City of West Linn
PRE-APPLICATION CONFERENCE MEETING
July 17, 2008

SUBJECT: 10-lot subdivision at 23150 Bland Circle.

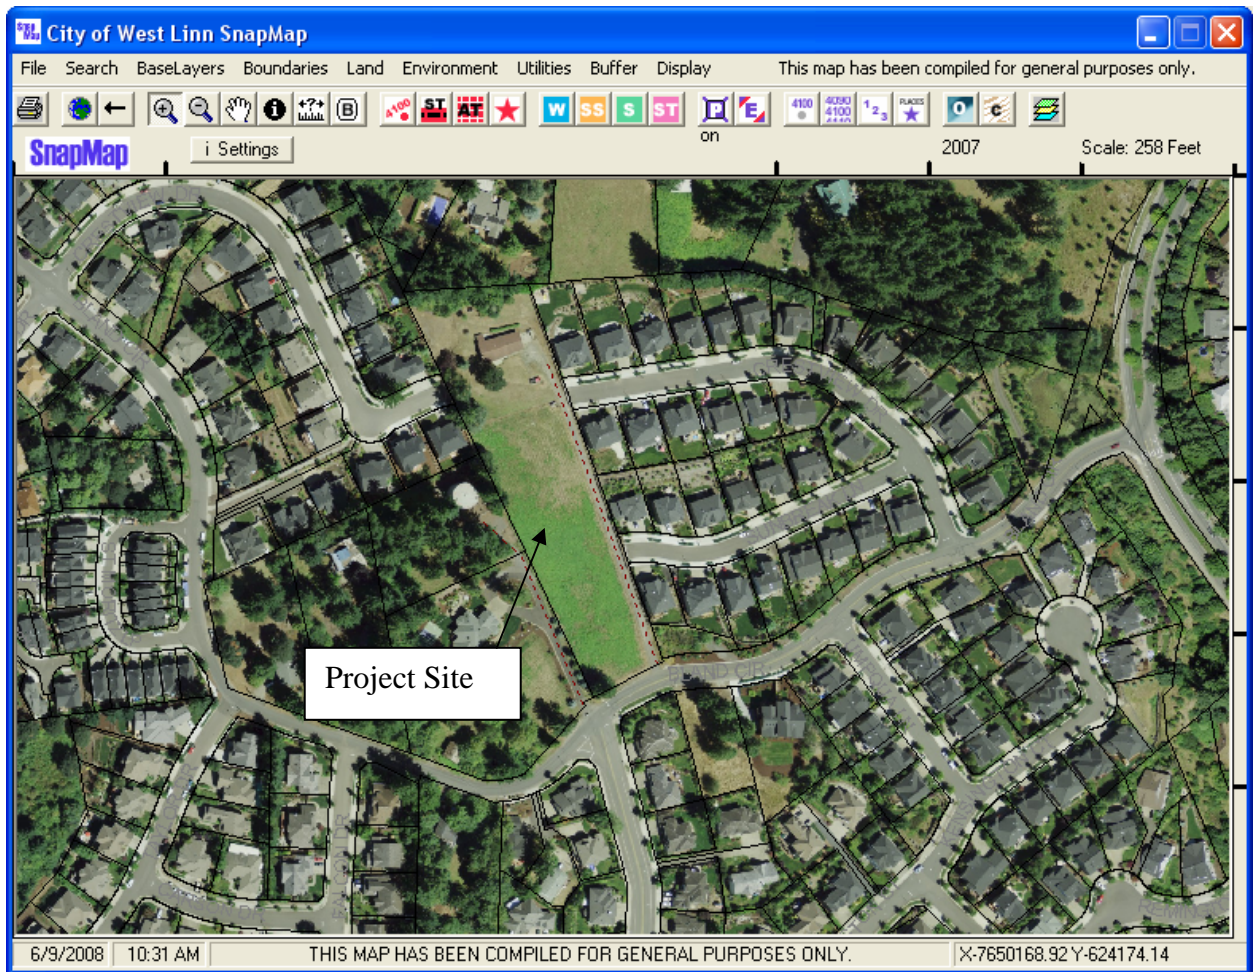
There is no connection or stub at this time from this part of the neighborhood towards Weatherhill Road. In order to fulfill the Transportation Planning Rule connectivity requirements, the applicant should ideally provide a street stub to the north from the new section of Crestview. This may result in losing either lot 1, 2, or 3 from the conceptual plan, but if configured right the applicant may still be able to have three lots north of Crestview Drive surrounding such a stub; any two of the three currently proposed lots would add up to more than 14,000 square feet after all. (Also, the block containing 4-7 could be reconfigured to contain one more lot to make up for the loss of 1, as the combined total of these lots is theoretically enough to create 5 lots total instead of the proposed 4.) If a street stub is not provided here, a pedestrian trail ROW should at least be provided; this should definitely not result in loss of lots from the conceptual plan. As

part of the application's plan set, the applicant should show how the Sunbreak Lane might be developed west of the site eventually (by other property owners) and where it might connect with other streets.

Crestview Drive, Sunbreak Lane, and the northern stub (if built) would have to be built to City local street standards with sidewalks and planter strips. Half-street improvements would be required along Bland Circle. The submitted conceptual plan shows the only lot that borders Bland Circle, Lot 10, as a flaglot with a stem connecting to Sunbreak Lane from which its driveway would access. This is therefore a through lot, and would not be allowed by 85.200(B)(5) as a through lot unless the applicant could make the case that it is necessary due to the topography or orientation issues of the site, which is unlikely. It appears it is feasible to access Lot 10 from Bland Circle and still achieve compliance with regulations on driveways being 35 feet or more from collector-collector intersections (i.e. Tannler and Bland), and 75 feet from another driveway on the same side of the street on a collector, but this may not sit well with the neighborhood as there are already awkward issues surrounding the Tannler/Bland intersection. Another possibility is for Lot 10 to access through an access easement across Lot 9 instead of a stem, which would allow it to avoid Bland Circle while keeping it from being a through lot. If access is taken from Suncrest, the flaglot aspect of the lot can be eliminated aesthetically if the house faces Bland Circle with a garage in back. Aesthetically this may be preferable to having a garage access from Bland Circle also.

The site slopes from north to south, and the storm drainage pond is planned along Bland Circle next to Lot 10, as this is the south end of the site. A pipe coming from Crestview Drive to the north would traverse lots 4, 6, and 8 in an easement. There is a large tree that the applicant prefers to not remove in the area where the stormwater facility is proposed. The applicant is interested in exploring whether he could do upgrades to facilities off site and have some of the site's water drain to there instead, which would reduce the stormwater facility on site and reduce impacts on the tree. Such off-site treatment facilities may include the facility that borders the south end of the site to the east, which was built for the Florendo's Hideaway subdivision. The sidewalk and planter strip may also be allowed to be modified from the regular configuration to avoid the tree.

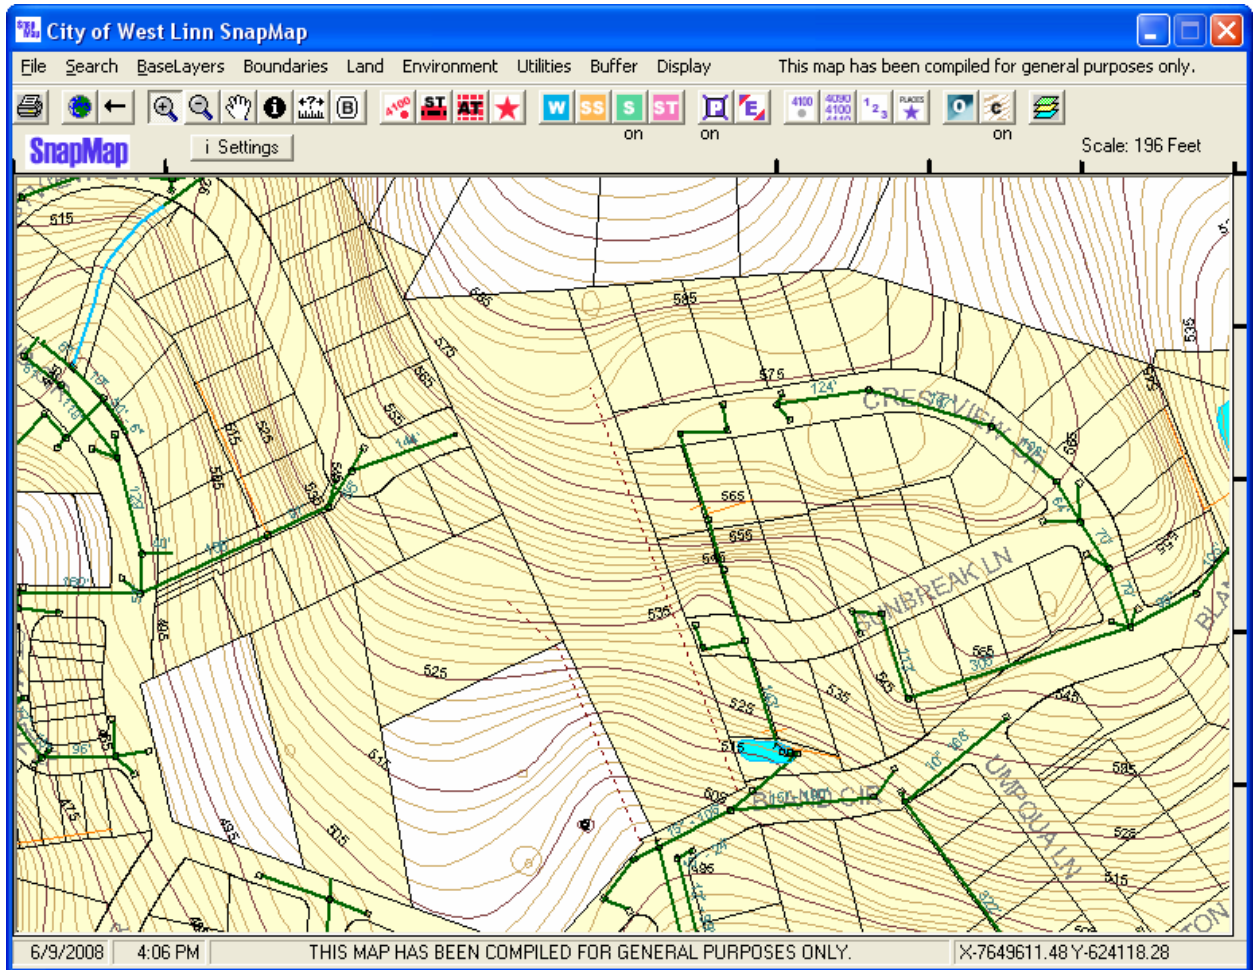
From the site plan submitted with the application, the developer proposed making connection for the existing Crestview Drive as well as extending Sunbreak Lane to provide access for the new homes.

Both Crestview Drive and Sunbreak Lane are classified as local route in the City Transportation Master Plan. ***For local route, the maximum right-of-way is 56' wide. The applicant proposed site plan shows 56' right-of-way. This proposal for the street right of way is appropriate.***

Bland Circle on the other hand is classified as a Collector. From the City Assessor Map, the current right-of-way along the proposed project frontage is approximately 50' wide. For Collector without median, the recommended right-of-way is 58' wide. ***Therefore, applicant shall require dedicating 10' wide along the project frontage. The applicant shall demonstrate that the radius of proposed center line of the roadway along the project site shall be adequate for future roadway improvement west and east beyond the property line. Larger dedication shall be required if necessary.***

*Half street improvement shall be required along project frontage on Bland Circle.
Half street improvement shall include widening the road, rebuild the roadway
pavement to the existing center line of the travel lane as well as constructing curb and
gutter with planter strip and sidewalk.*

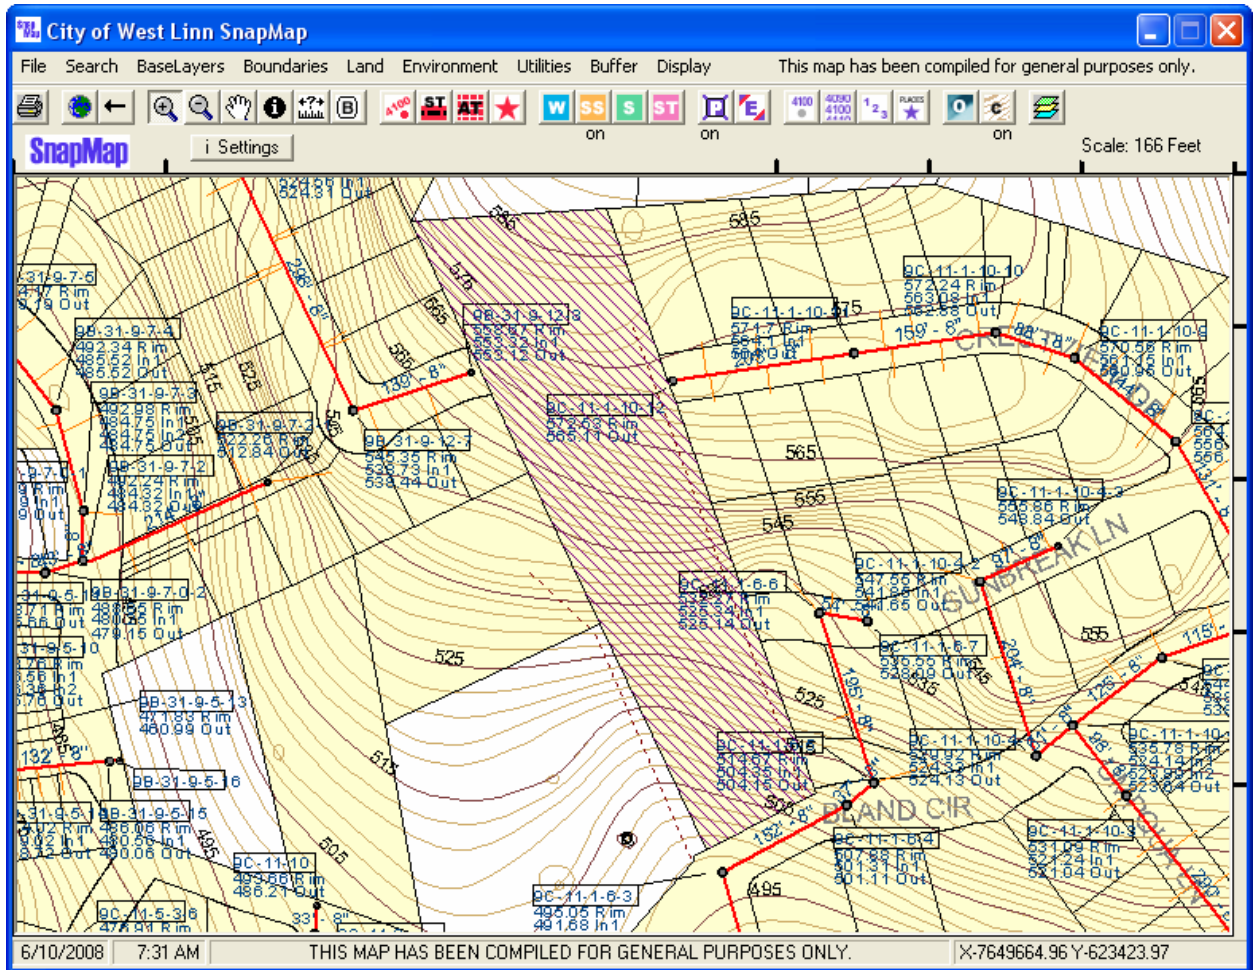
The proposed stormwater conveyance system plus a designated area for water quality and detention on the submitted plan should work well.

The applicant shall address how run-off along Bland Circle in front of the development is captured, treated and detained before discharging into the existing public system.

The applicant shall address how roof run-off is captured and conveyed.

The location of the detention pond may be in conflict with the location of a significant tree to be saved. The applicant shall check with the City Arborist to find out whether or not the existing tree is to be saved.

Storm drainage report shall be required for the reviewing of water quality treatment and detention as well as flow control calculations.

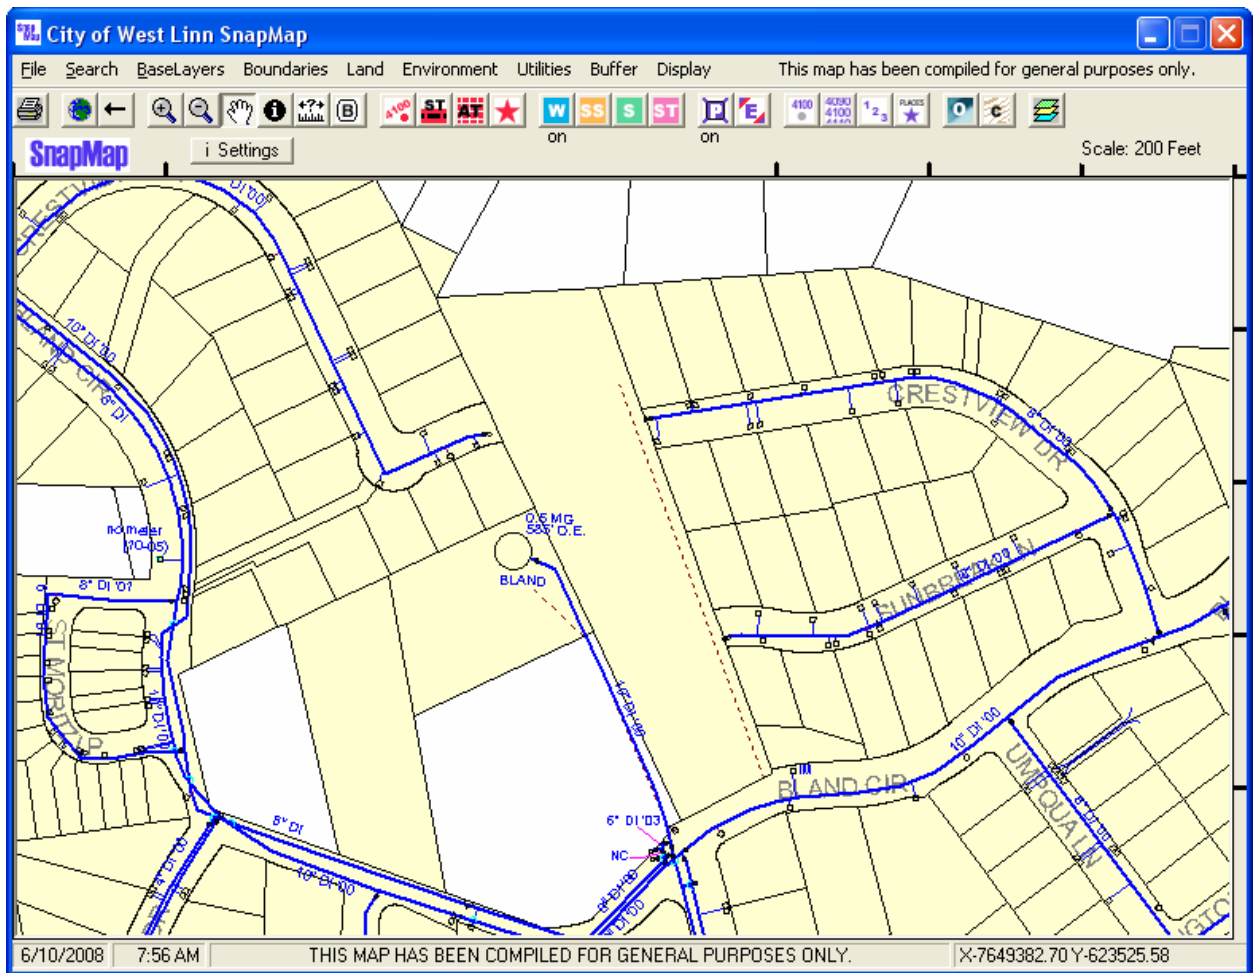
From the City record indicates that there is existing public sanitary sewer system available for connection along Suncrest Drive. The proposed sanitary sewer system on the submitted plan should work well.

The existing clean out located at the end of Crestview Drive west of the proposed property shall be replaced with a manhole.
